ADDENDUM # 3

Concerning the **"PSJA ISD AGRICULTURAL FACILITY PHASE I BID # 18-19-003"** to be opened at 4:00p.m., Thursday, OCTOBER 4, 2018. Please consider the following:

**ADDENDUM NUMBER THREE (3)
TO THE PLANS AND SPECIFICATIONS FOR:**

**PSJA Agricultural Facility – Phase I
PSJA ISD
Bid #
Project No. 16.08**

ALTERNATIVE 3

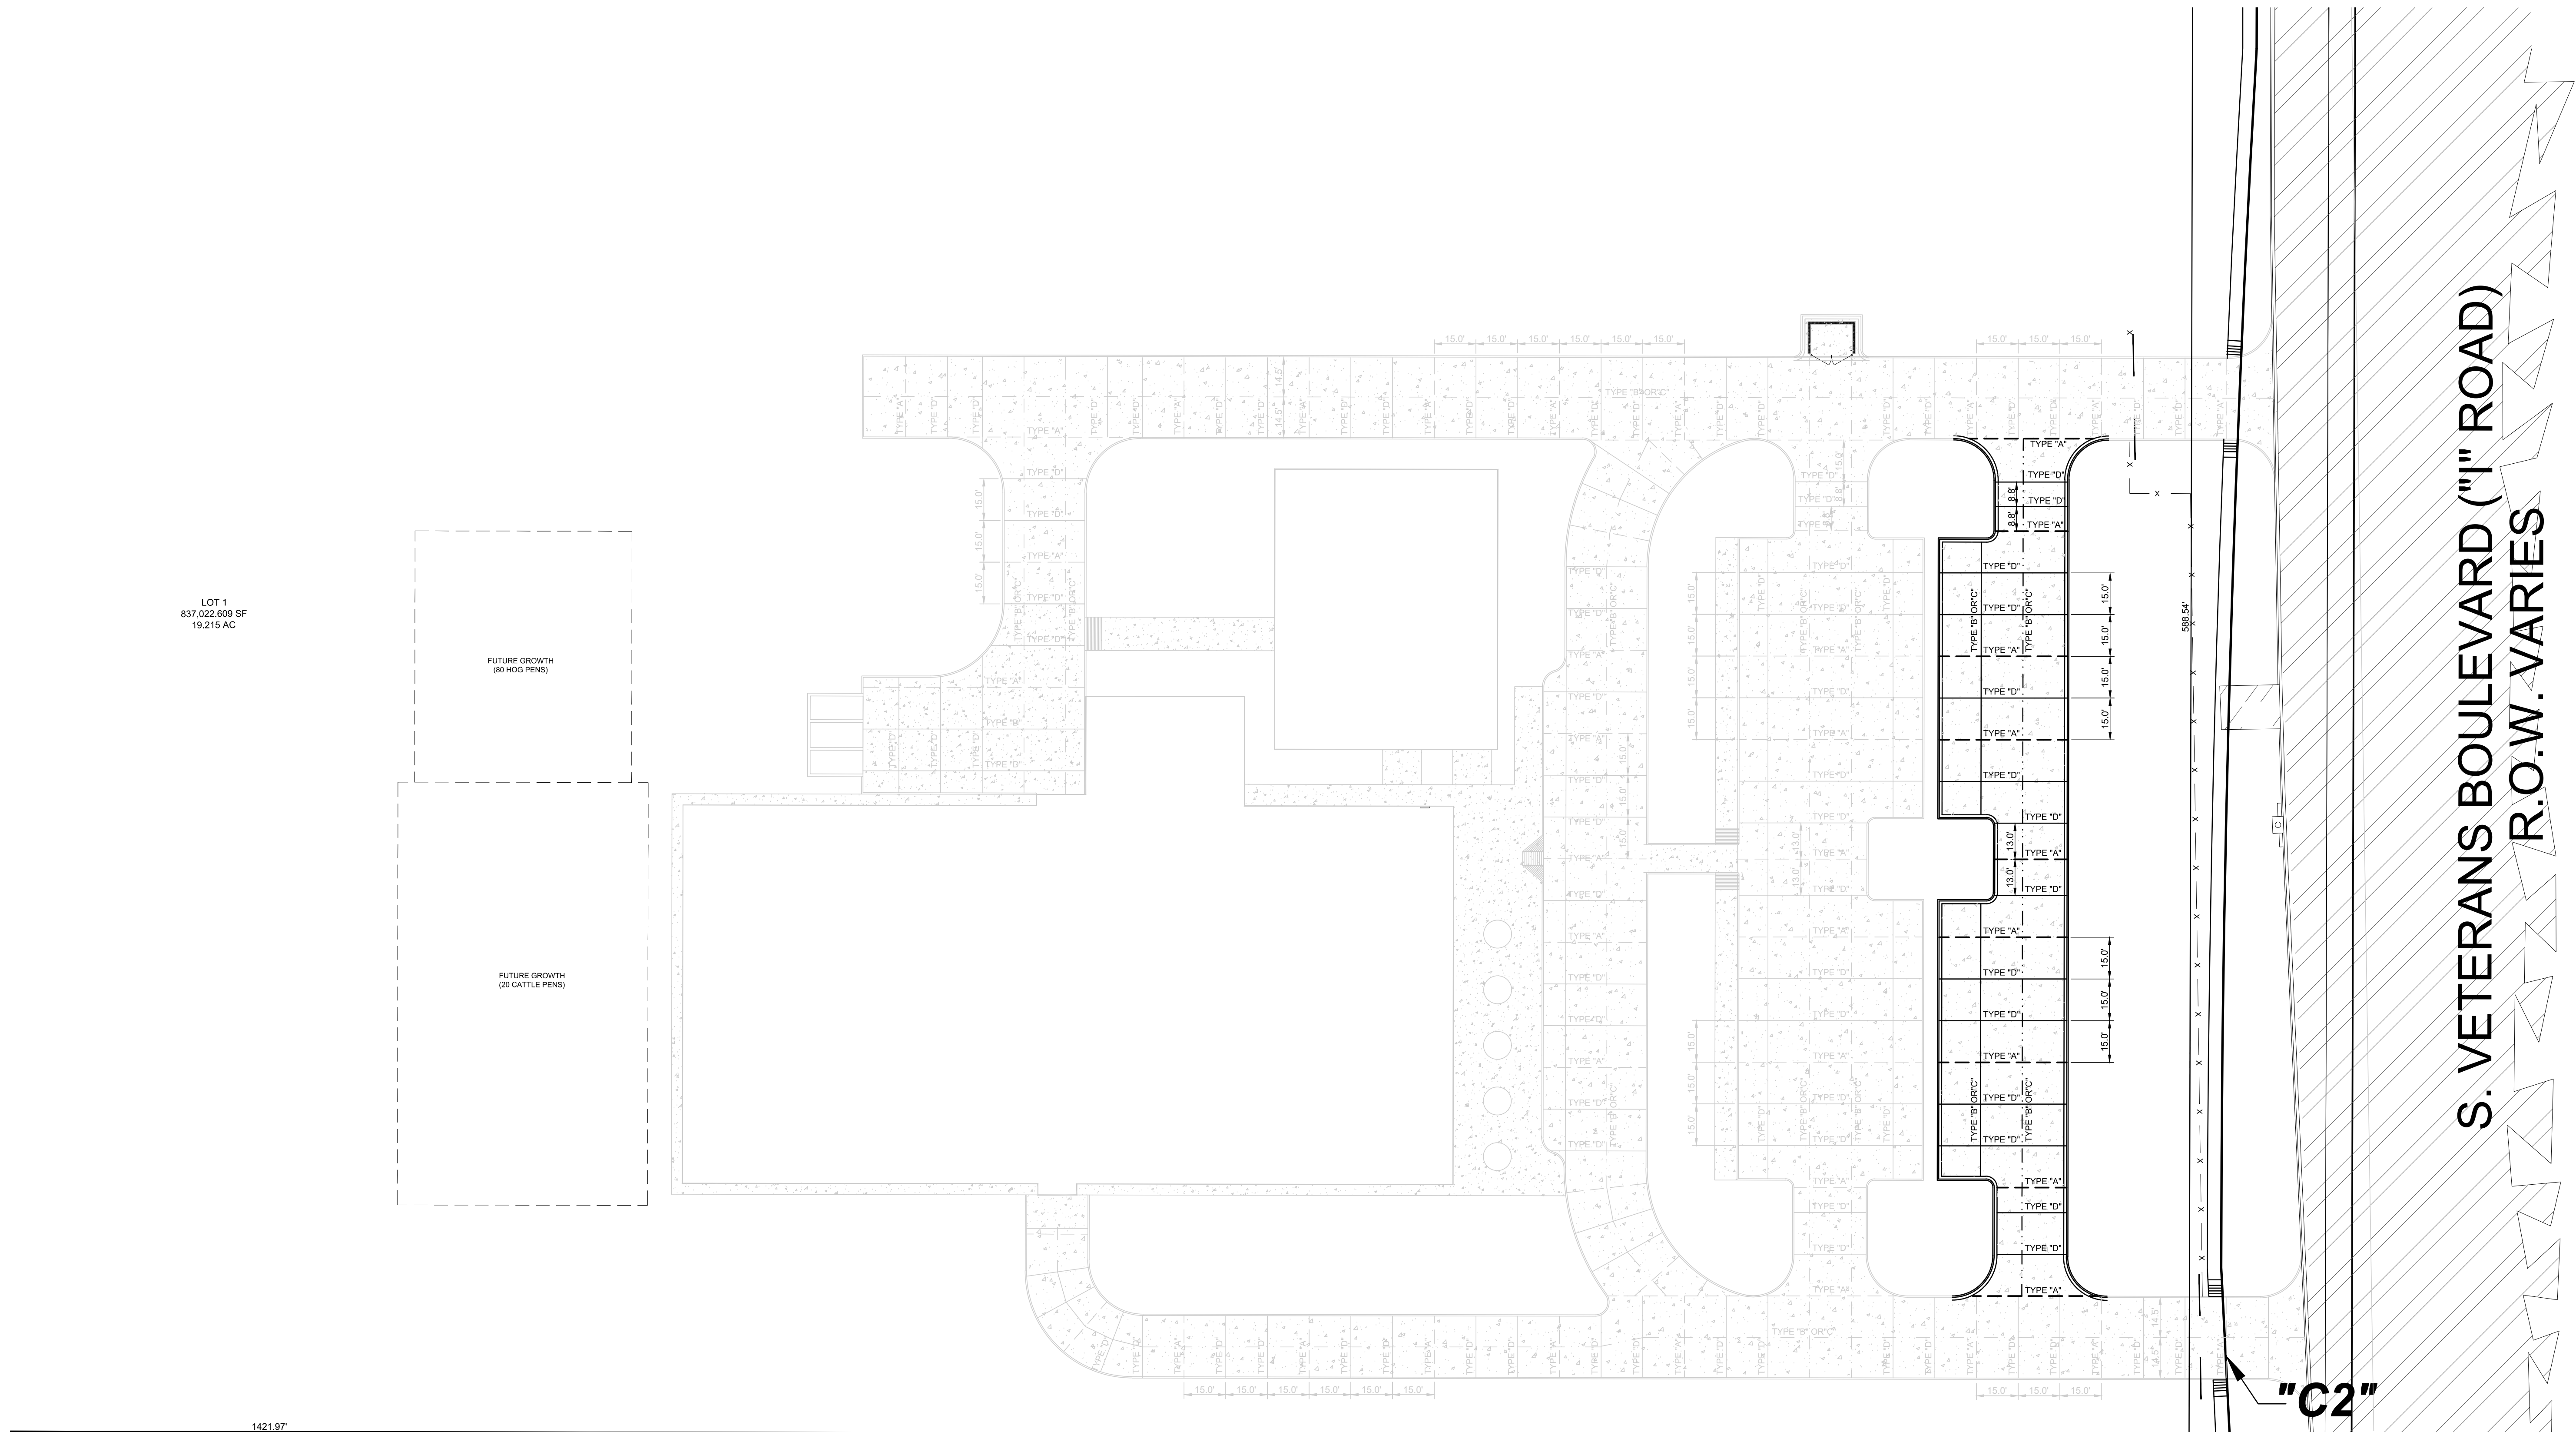
RFI: Sheet C-10 is titled Alternate 3. please clarify if in fact there is an Alternate 3.

Refer to Section 012300 Alternates regarding what is listed under Alternate 1, Alternate 2, and Alternate 3. Also see attached revised Sheet C-10 for clarity.

1 FOUNDATION PLAN 1/8" = 1'-0" ALT #1

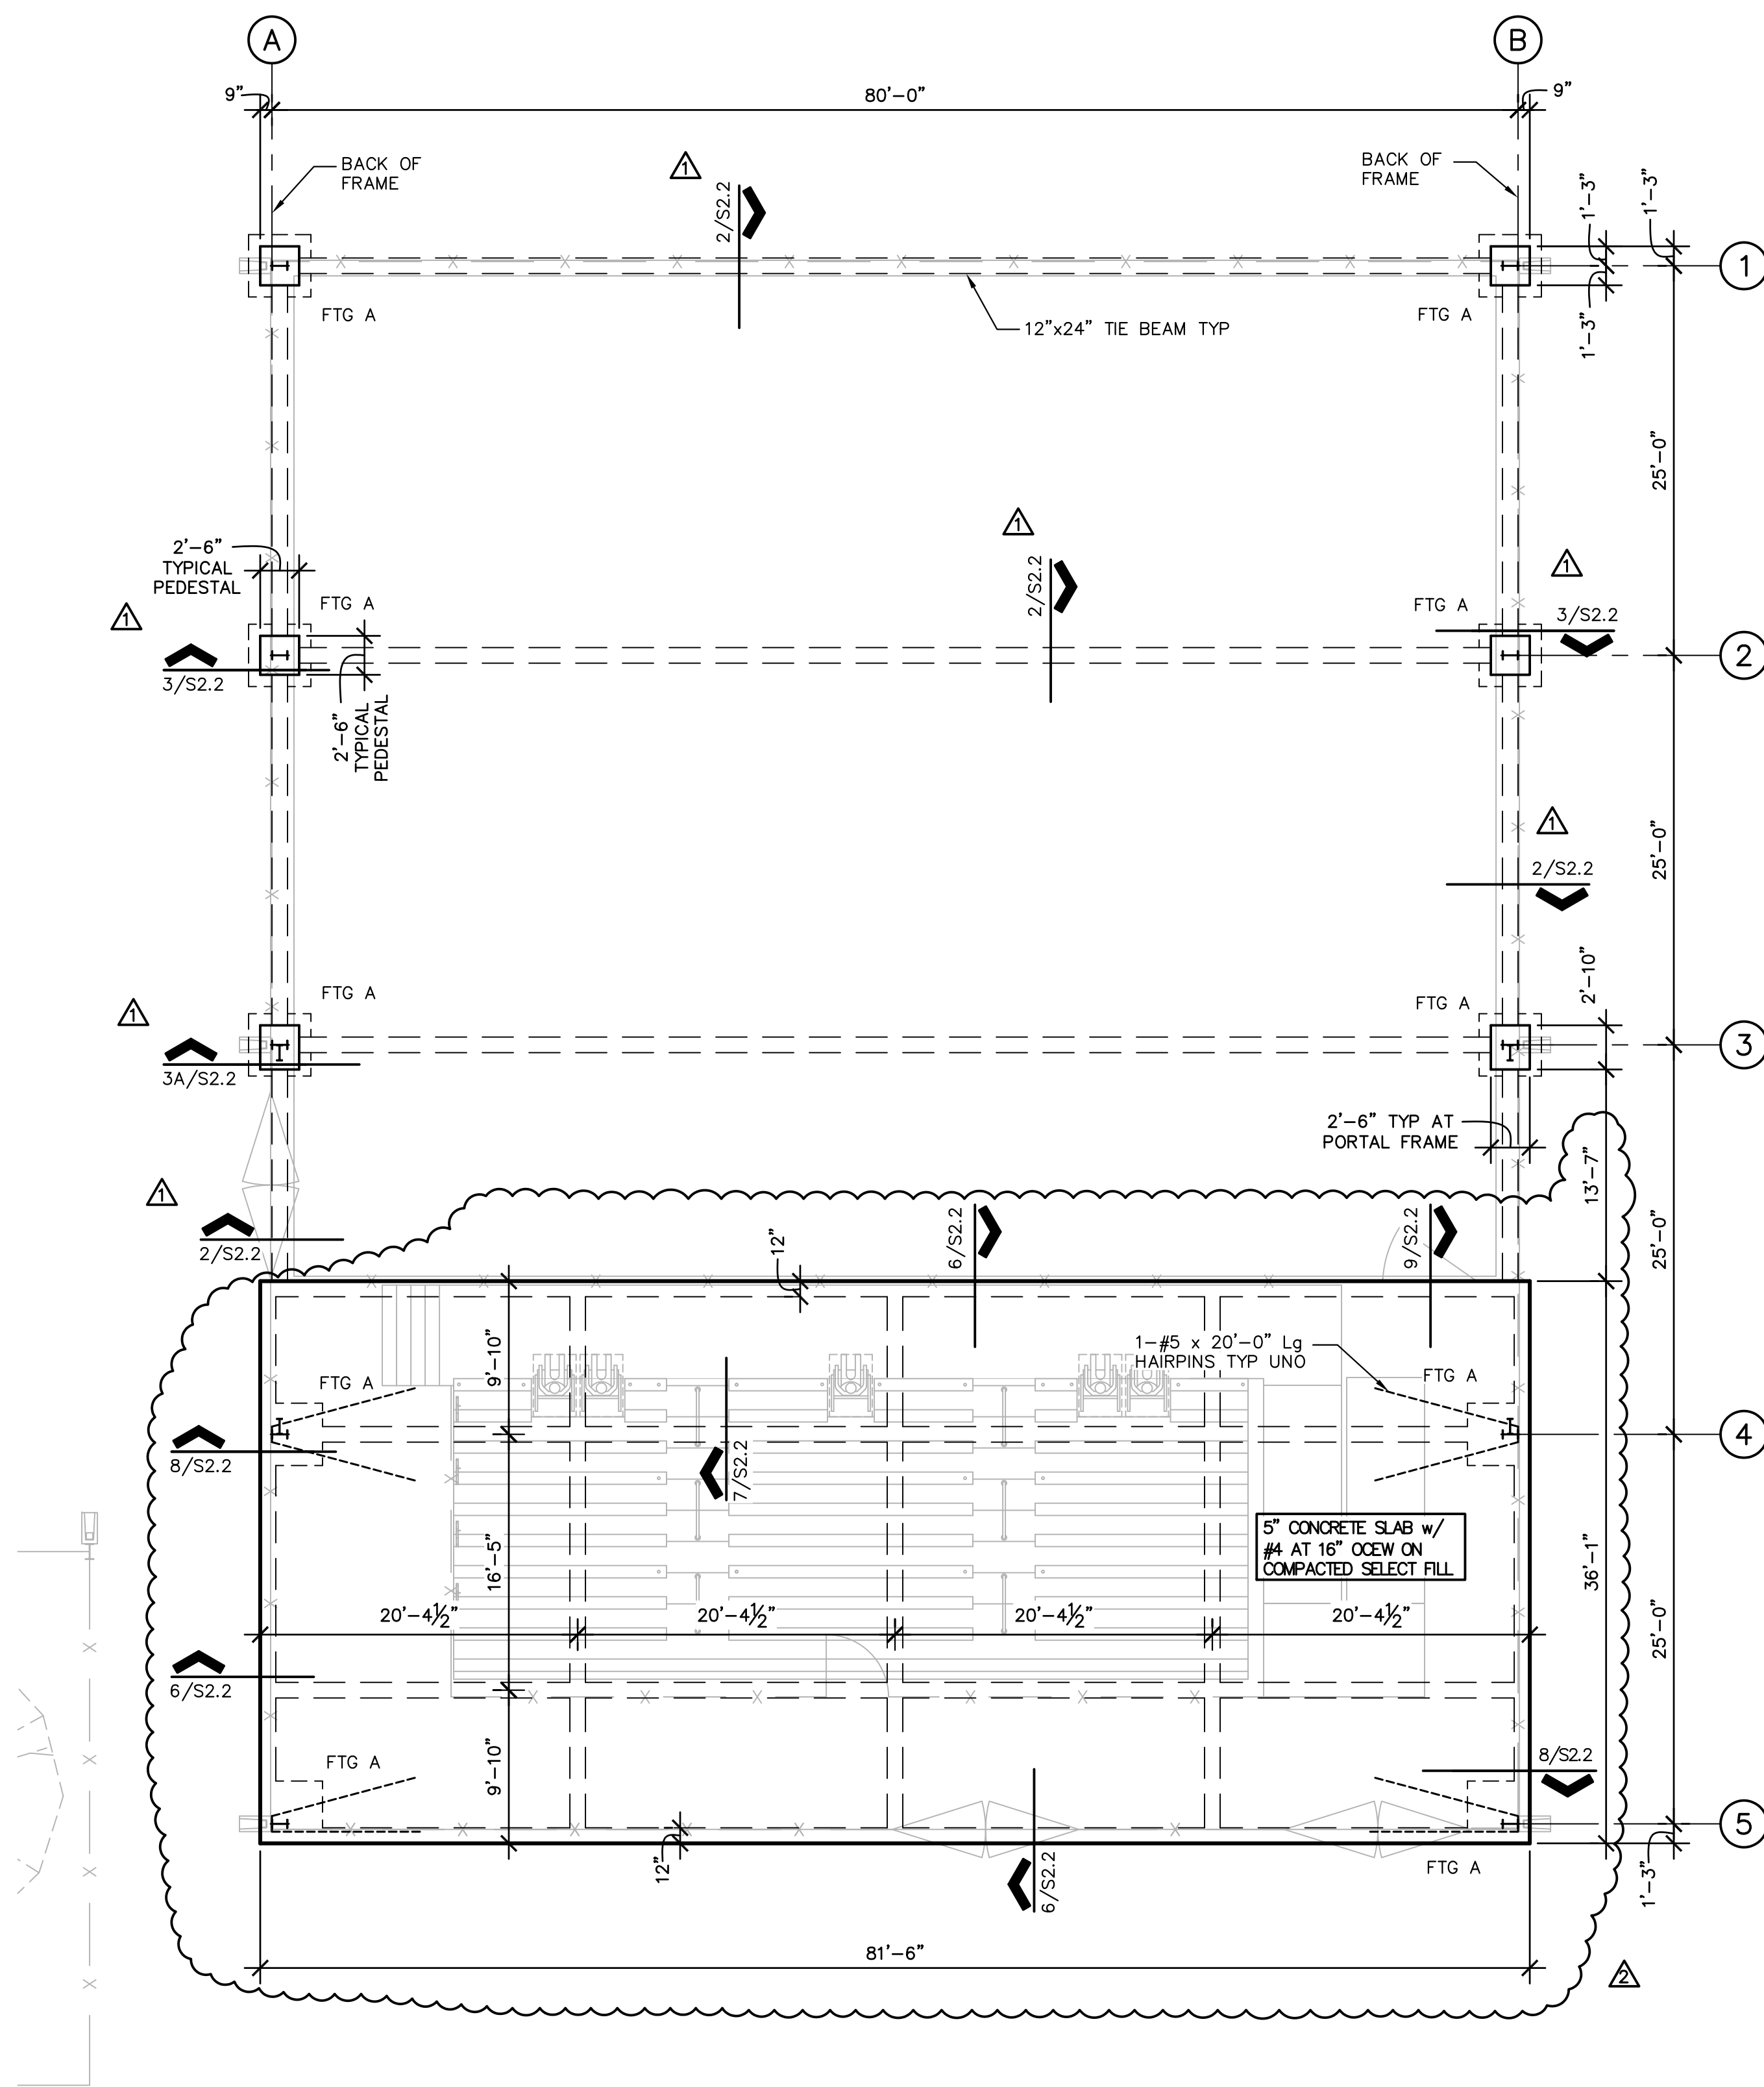
RFI: See attached sheet S2.2 alternate #1 foundation has no slab in Exercise Arena. What do you want for general contractor to place in Exercise Arena for example top soil, sand, etc.... . Please verify/clarify.

Refer to revised Sheet S2.2-R2 for clarification regarding slab in Exercise Arena.

Owner has stated earth and 6" of sand for the area where the animals will exercise in the arena.
